Number: FS-2017-05

Model: All Buses

**Subject: Removing "Duck Bill" Valves In Rear Run Box**

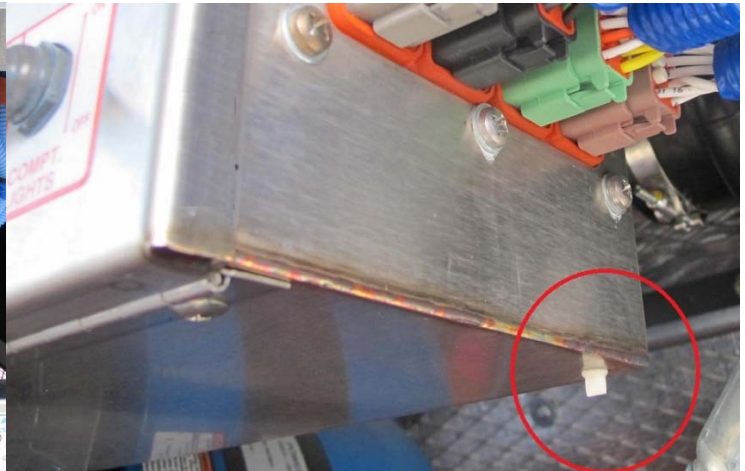
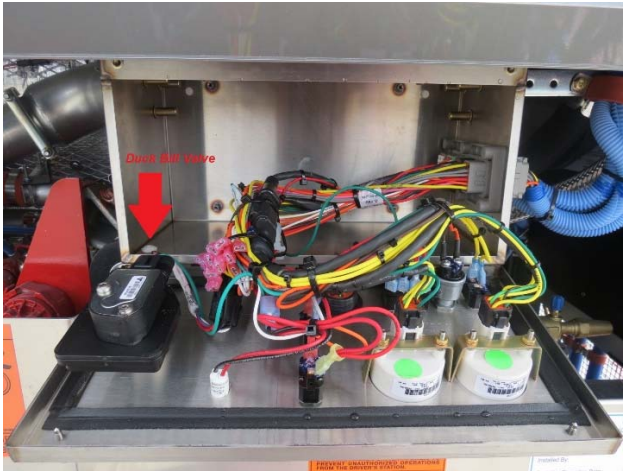
***We have found that the 'duck bill' valves in the bottom of the rear run box can keep water trapped inside the box.***

***This water remaining inside the rear run box can keep moisture trapped, and contribute to corrosion of some components.***

***We ask that you remove the duck bill valves to allow all the water to drain out.***

**These instructions cover the removal of (2) duck bill valves, part number 13-72036-000, from the rear run box assemblies for the purpose of improving drainage.**

**Procedure: Refer to the diagram below for item number locations.**

**1. Loosen two thumb screws (item 3) and allow the rear run box door (item 2) to open.**

**2. Locate and pull out duckbill valves (item 5) at the two locations shown.**

**3. Inspect door gasket for damage or debris and wipe clean if necessary using isopropyl alcohol before closing and securing with the two thumb screws in step 1.**

**4. Tighten screws by hand only, do not use tools. Apply mild pressure to the door with a second hand, allowing the gasket to compress and thumbs screws to fully thread into box.**
